**LEGAL ADVERTISEMENT
PORTLAND PLANNING BOARD MEETING**

The Portland Planning Board will hold a meeting on June 10, 2014, Council Chambers, 2nd Floor, City Hall, 389 Congress Street. **Public comments will be taken at both the workshop and public hearing.** The agenda includes the following items:

- ii. International Marine Terminal, 528 Commercial Street, Level III Site Plan Maine Department of Transportation, Applicant. The Board will hold a second workshop on a proposal to expand the International Marine Terminal (IMT) at 460 Commercial Street. The proposal includes rail improvements, site improvements for shipping container and chassis storage yard, coordination with adjoining uses, West Commercial Street improvements; and repairs to existing fenders east of Casco Bay Bridge.

Filename: 006_SiteGradingPlan3.dgn

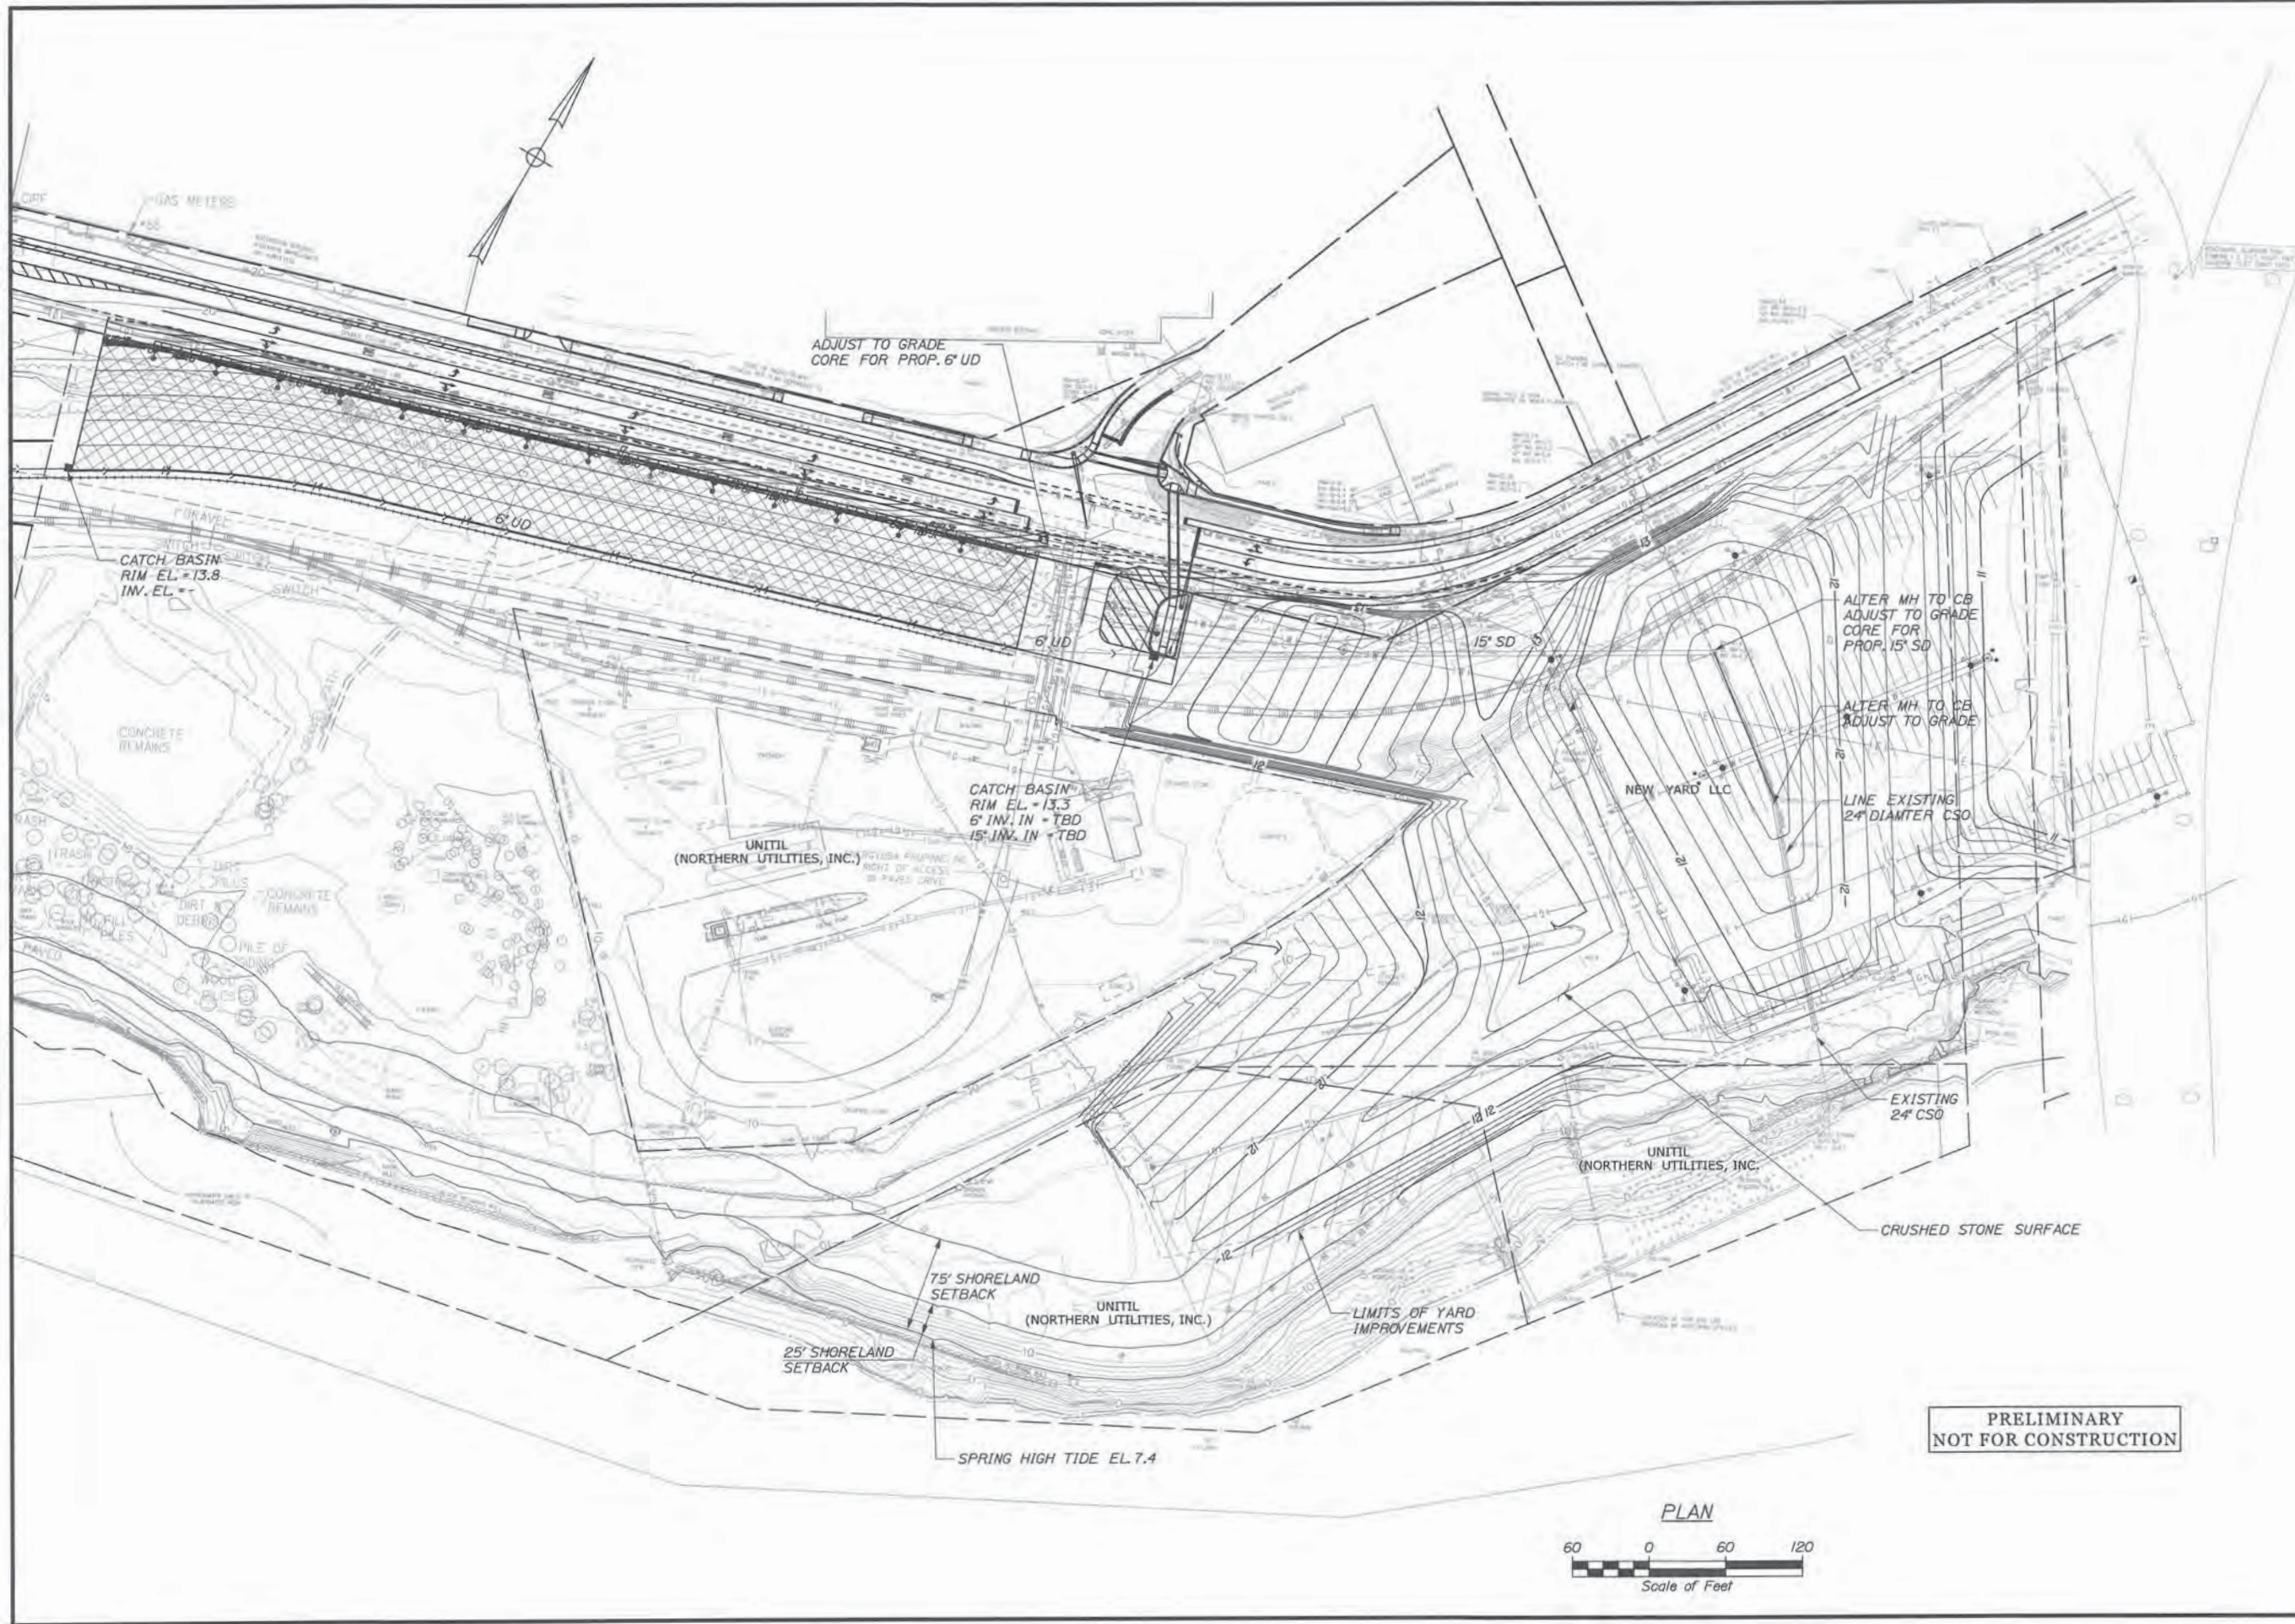
- 2) The proposed contours on Sheet C8 (Site Grading Plan, 11 of -) are not clearly labeled, but show alteration of possibly the entire VRAP area; this is not discussed in the stormwater report or other material received. Is that area proposed for development as part of this project? If so, there could be additional questions related to the proposed plan of development in the VRAP area. As discussed in my response to item #1, the proposed disturbance to the VRAP area is limited to only minimal excavations as noted in item #1 and installation of the 24" granular/crushed stone surface. No excavations are proposed that could extend into the VRAP envelope and therefore we feel that improvements in this area will not have negative impacts on the VRAP area. The AMEC report does not make recommendations limiting future use of this area upon completion of the VRAP. We feel that development of this area, and for the rest of the site for that matter, does not have a significant impact on the underlying soils. Marybeth had indicated following up with Nick H regarding the VRAP. Who is Nick and how would he be able to help out with this?

The proposed grading shown on Sheet SW2 and SW6 in Appendix D of the Stormwater Report and Sheet C8 - Site Grading and Drainage Plan do not appear to match. The Applicant should clarify.

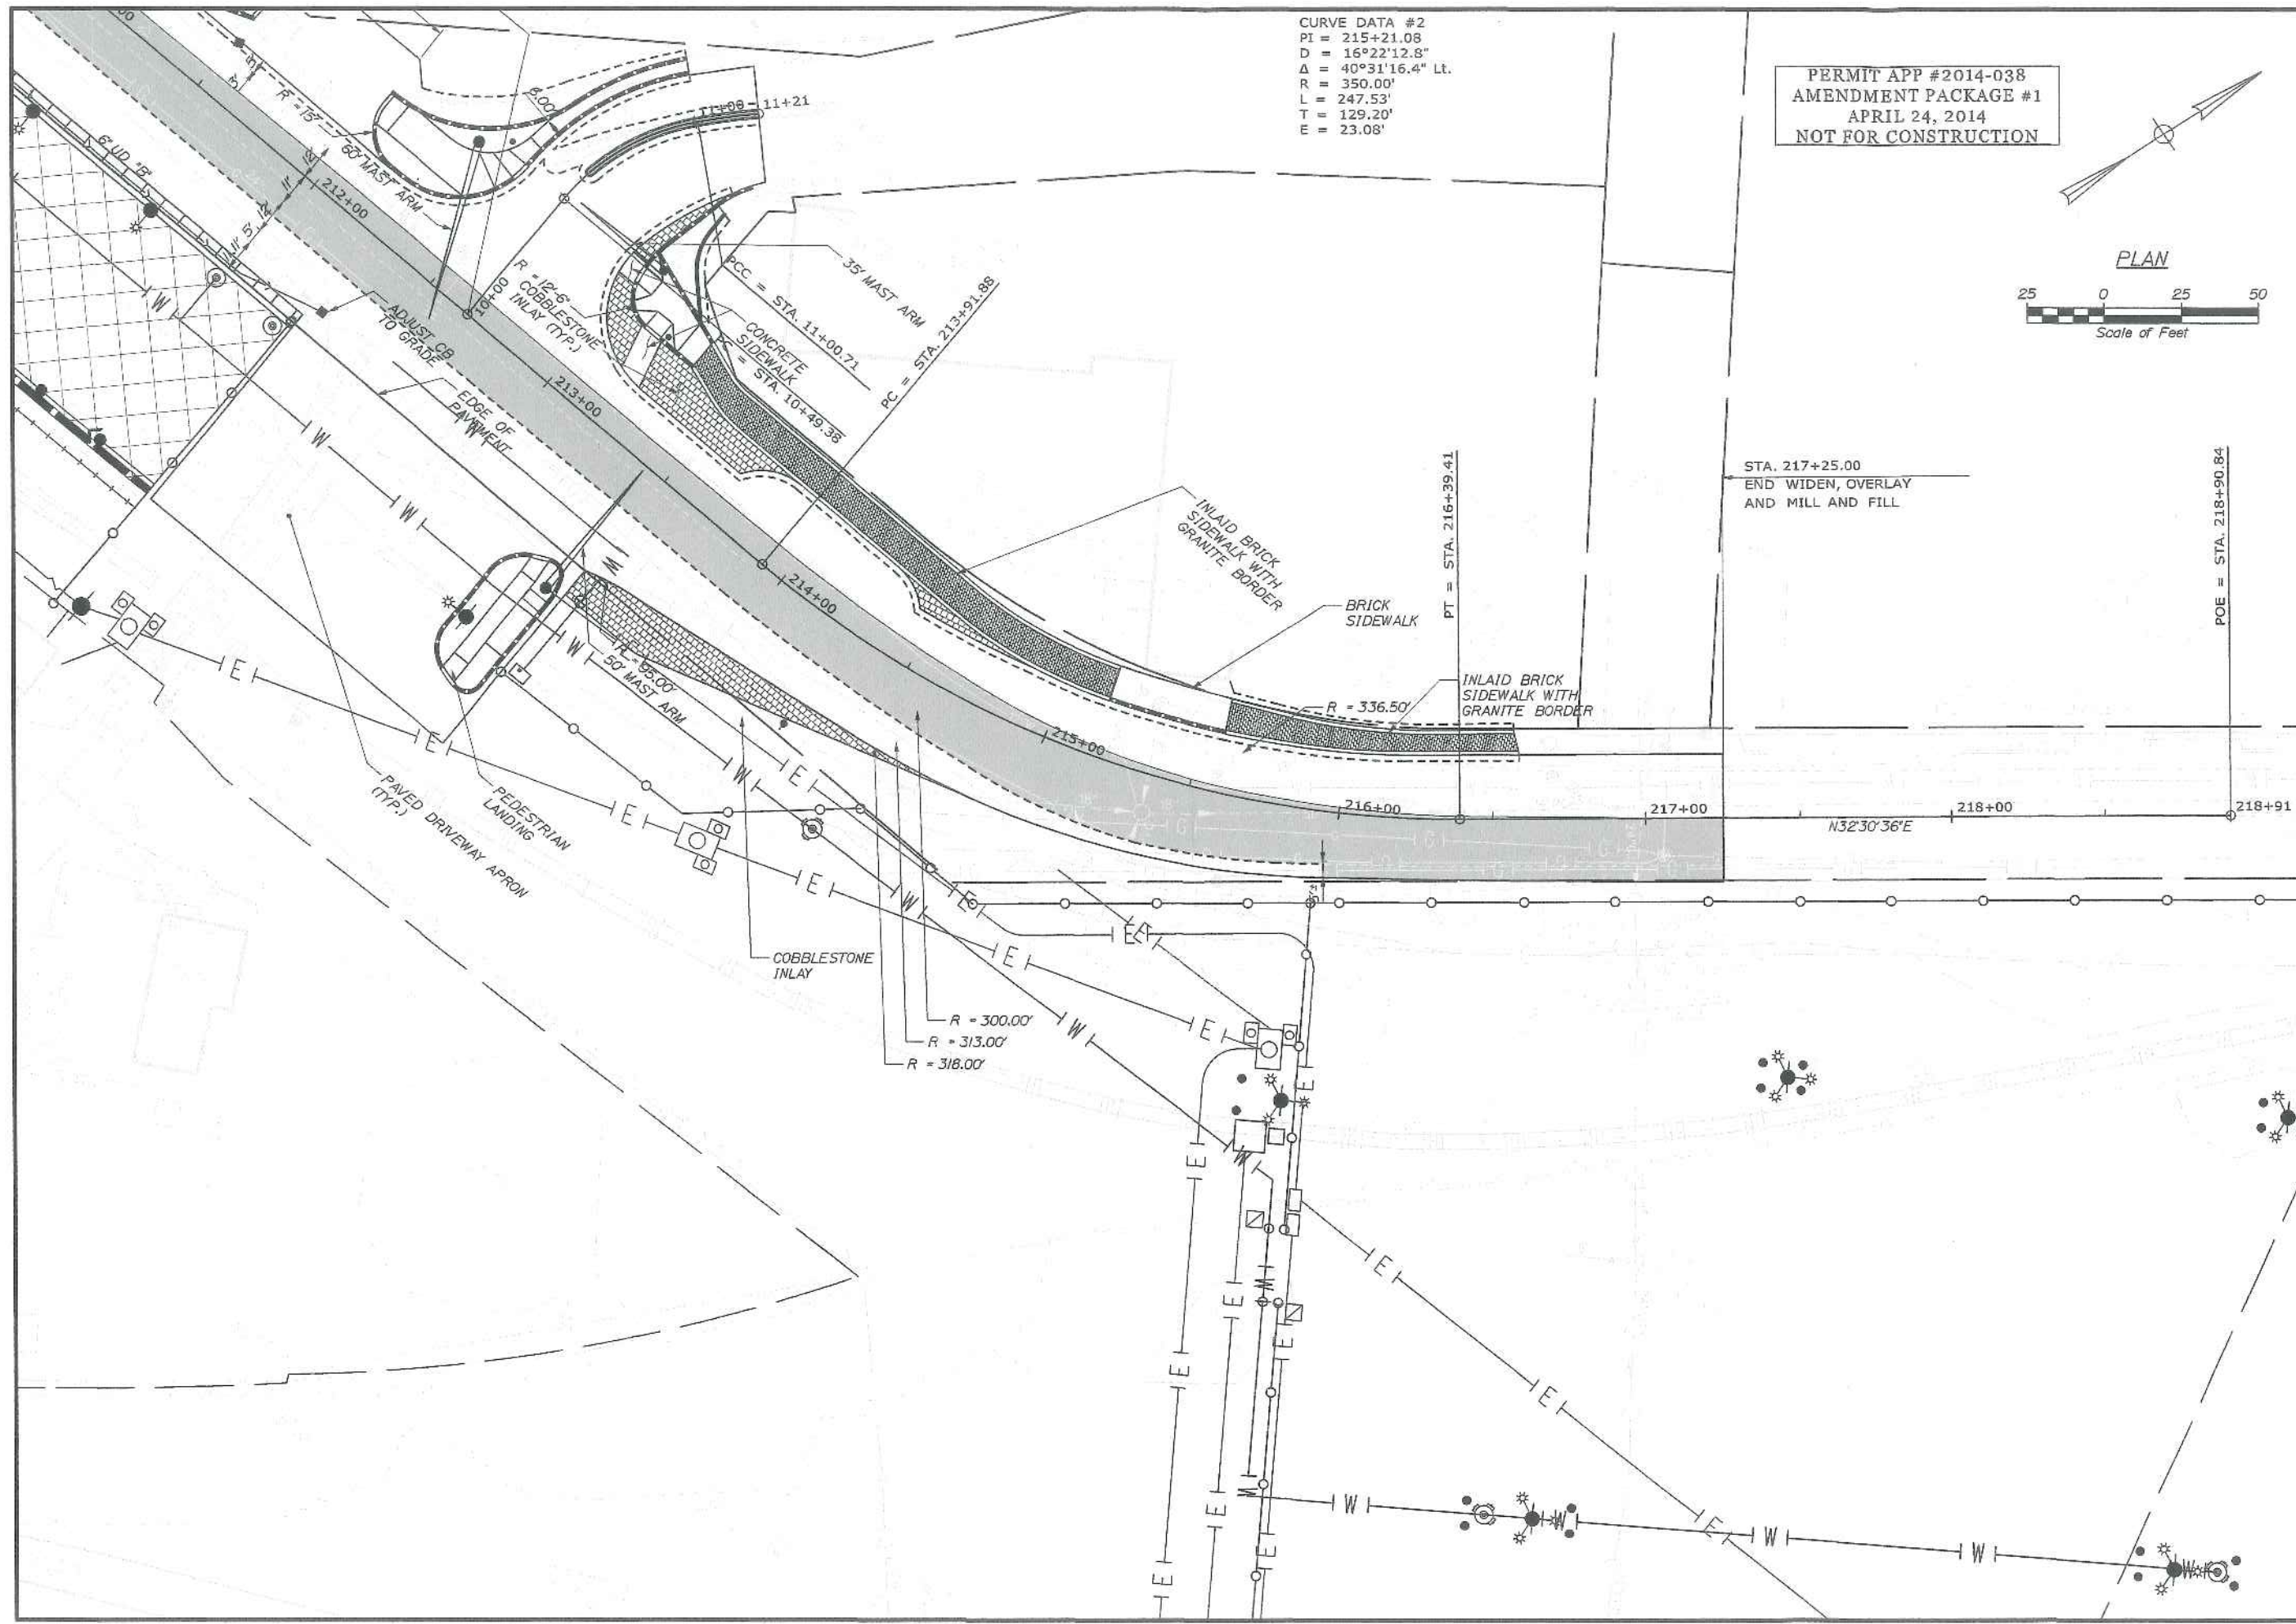
- Plans R1 & R6-R8, related to the proposed rail track from Cassidy Point to the proposed loading slab (dated April 4, 2014)
- Sheets E01 & E02 - Electrical Plan Parts 1 & 2 (dated 2/26/14)
- Sheet H4 - Commercial Street Plan (dated 03/14)
- Sheet C9 - Site utility plan (dated 03/27/2014)
- Sheet C17 - Site Operations (dated 01/2014)
- Sheet C17 Fire Protection Plan (dated 01/2014)
- Site Survey plans by Owen Haskell, Inc. (dated March 2014)
